ATTACHMENT 1

TECHNICAL SPECIFICATION 6.0

ADMINISTRATIVE CONTROLS

FIGURE 6.2-1

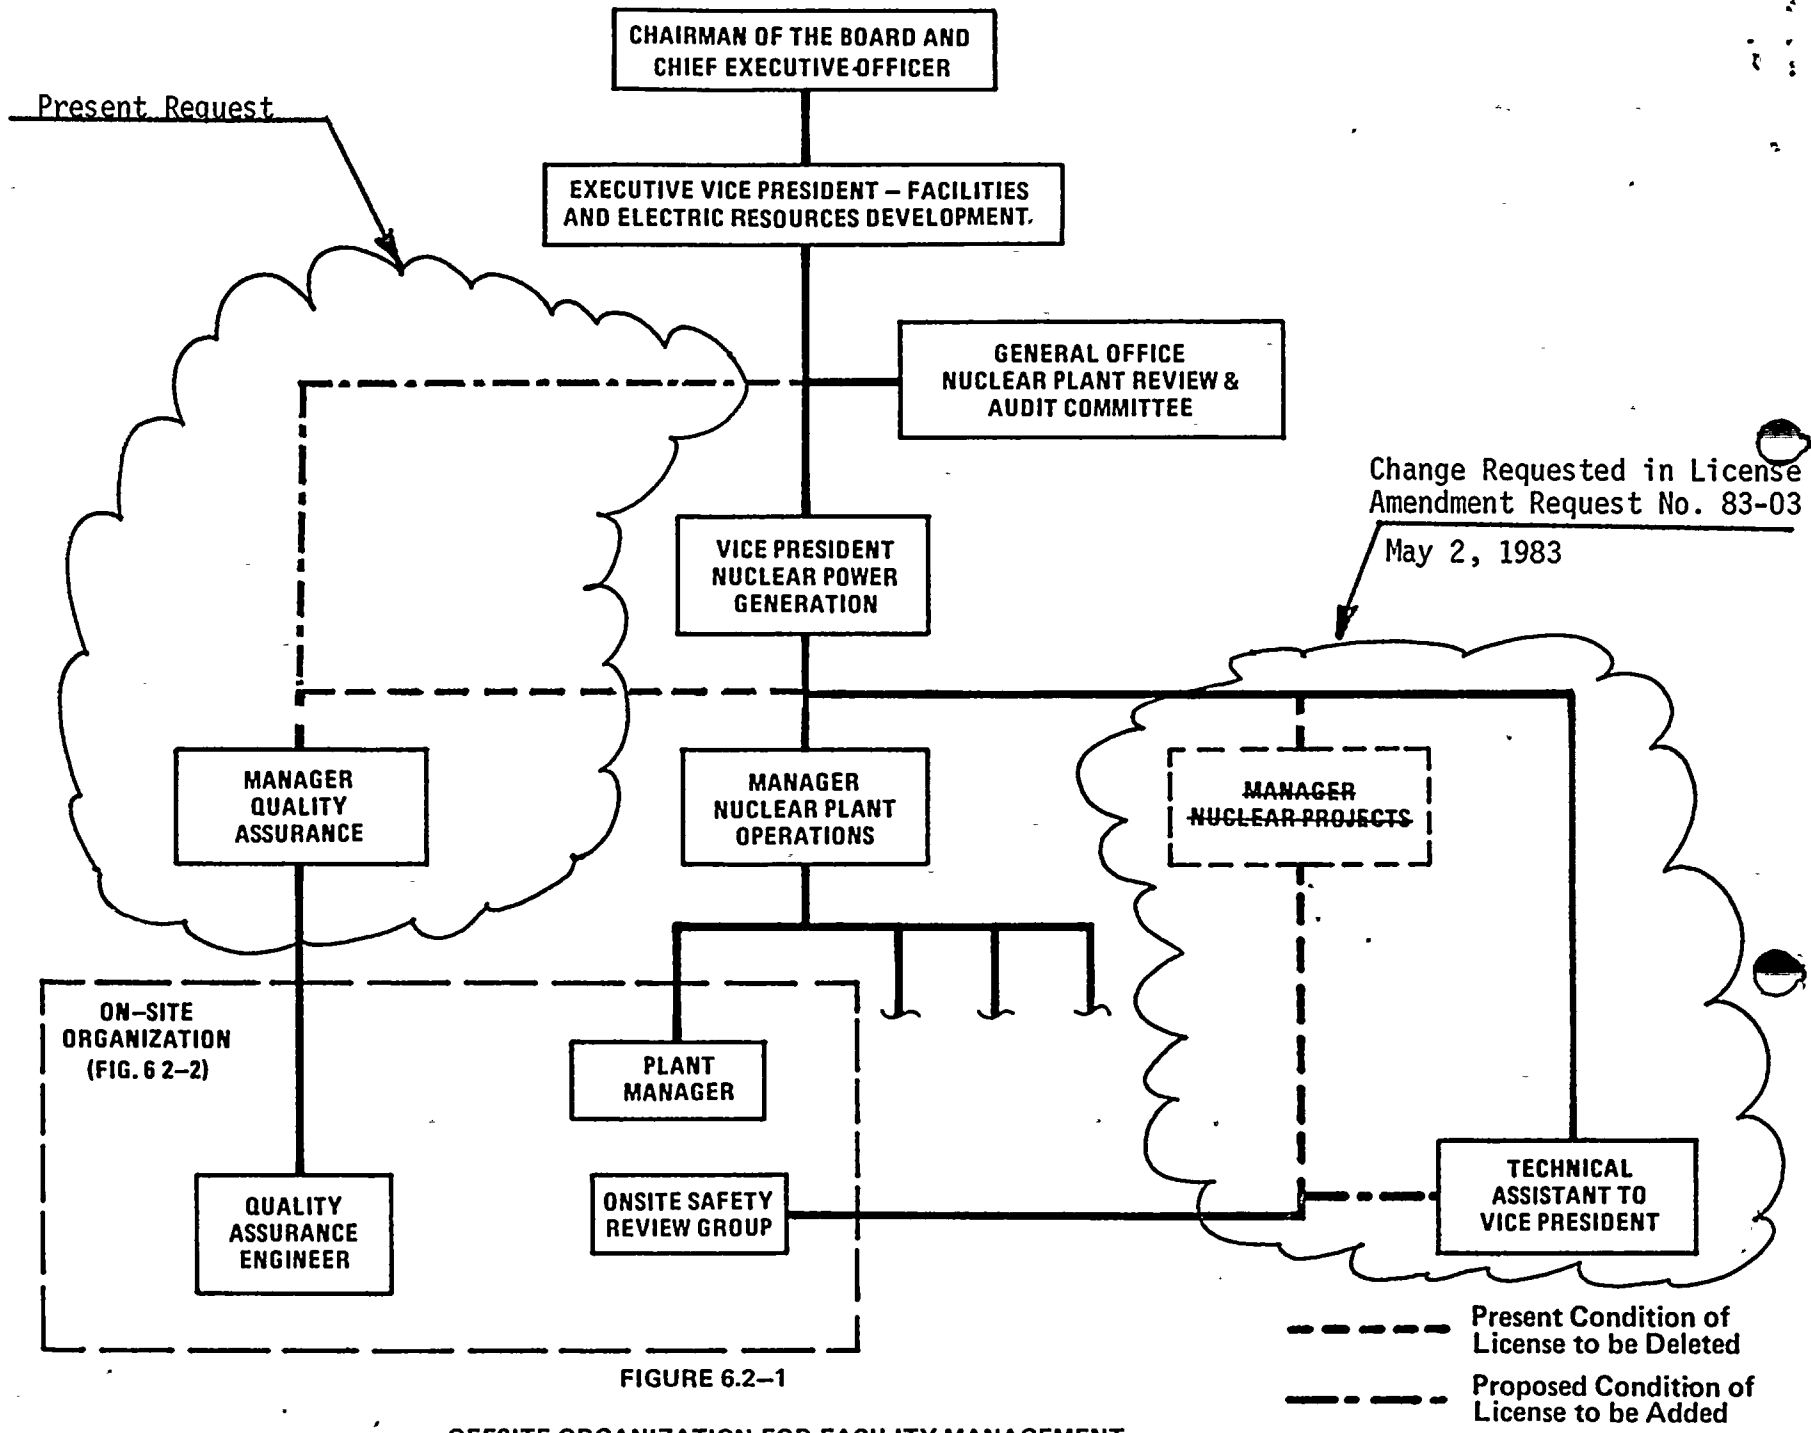
The facility organization for DCPD shows the Manager, Quality Assurance, reporting to the Vice President, Nuclear Power Generation.

The Manager, Quality Assurance, reports to the Executive Vice President, Facilities and Electric Resources Development. The change discussed above is shown in the attached page 6-2, of the Technical Specifications.
